Notice of Decision

Project No. PRJ14-00023

File No. AAS16-00006

Riva Townhomes Administrative Adjustment of Circulation

Fig. 2. Newport Way Required Improvements

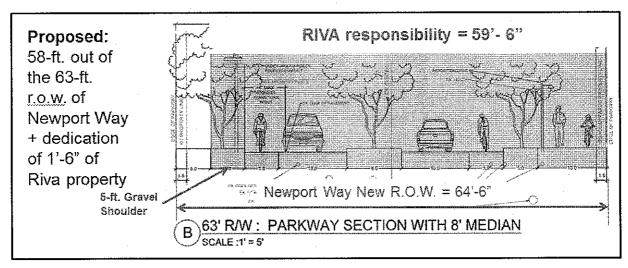
The Applicant is required to build frontage and street improvements of Newport Way, from the property line of the Riva project site to the gravel shoulder on the opposite side of Newport Way (Shown as the area in blue in Fig. 2, Newport Way Required Improvements). The proposed cross-section for Newport Way accommodates a wider shared use route than the prescribed 6-foot wide sidewalk in the CIDDS. The widths of the various elements of the Parkway were adjusted to also accommodate the existing 5-foot wide on-grade bike lane on Newport Way, a 12-foot wide center turn lane or 8-foot wide landscaped median.

A 67' R/W: PARKWAY SECTION WITH 12' LEFT-TURN LANES

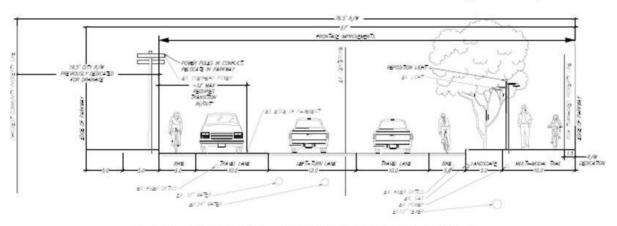
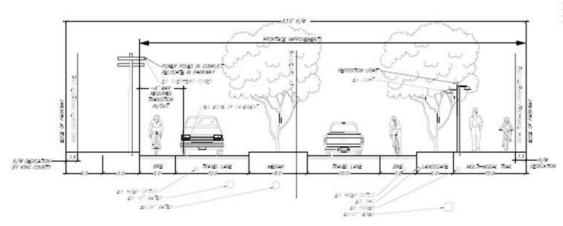
I vehemently oppose this request. The design standards were set up for a reason. With the parkway configuration, traffic is blocked on drivers left sides by the median. The only place to swerve and get out the way of an unexpected obstacle, such as a deer or a child, would be to the right. A mid-size SUV is a little more than 6 $\frac{1}{2}$ feet wide. Adding on the size of both side mirrors makes that another 16-20 inches, making the total wide almost 8 feet. With an 11 foot travel lane, it gives approximately less than 18 inches on each side of the vehicle. Shave off 12 inches for a 10 foot travel lane, and the driver of a mid-size SUV – not to mention the number of full size SUV's that travel Newport Way – has only six inches of leeway on each side.

My concern is where then will these vehicles go if they need to swerve at all? They will be forced into the bike lane next to it, potentially causing harm, injury and death to bicyclists traveling in their dedicated lane. The City of Issaquah cannot sacrifice safety, as they have for years on Newport Way, which has caused the death of a child and two dogs in a crosswalk, for the sake and profit of private developers. We need this extra room in the travel lane and the City should not allow this exception unless they want to show, once again, they value money over life.

Thank you for submitting your concerns about reducing the width of the travel lane on Newport Way from 11 feet to 10 feet. I would like to clarify that this proposal for adjustment of standards involves adding a 12-foot wide middle turn lane on Newport Way to accommodate cars trying to make left turns into the existing driveways of developments along Newport Way, and leaving in the 5-foot bike lanes, on grade with the roadway, on both sides of the street. Landscaped medians will only be installed where center turn lanes are not needed. The new center turn lanes are meant to relieve the congestion along Newport Way due to cars queueing to enter the various properties while blocking through traffic, as currently happens. The 5-foot bike lanes on both sides of the roadway accommodates the extra 6-inch that you mentioned below, for larger vehicles. Below is a section of what Newport Way will look like, for two conditions, with a median planter and a center turn lane:

I believe this would address your concern of not having enough room for cars to swerve around the main travel lanes. Reducing the travel lane to 10 feet is more consistent with the recent reduction in speed of traffic allowed on Newport Way, which was originally at 40 mph and reduced to 30 mph by City Council action. It also allowed us to accommodate a 10-foot wide sidewalk with bike lane along the side of the Riva property. The bicycle lanes at grade with the roadway accommodates commuter bicyclists who are comfortable riding next to cars, while the bike lane combined with the sidewalk accommodates children and other bicyclists who don't feel safe riding a bike with cars. In summary, the 10-foot reduction facilitates safer vehicle speeds, encourages more multi-modal transportation usage, and, with the added center turn lane and retaining the 5-foot commuter bike lanes, does not constrain vehicle movement.
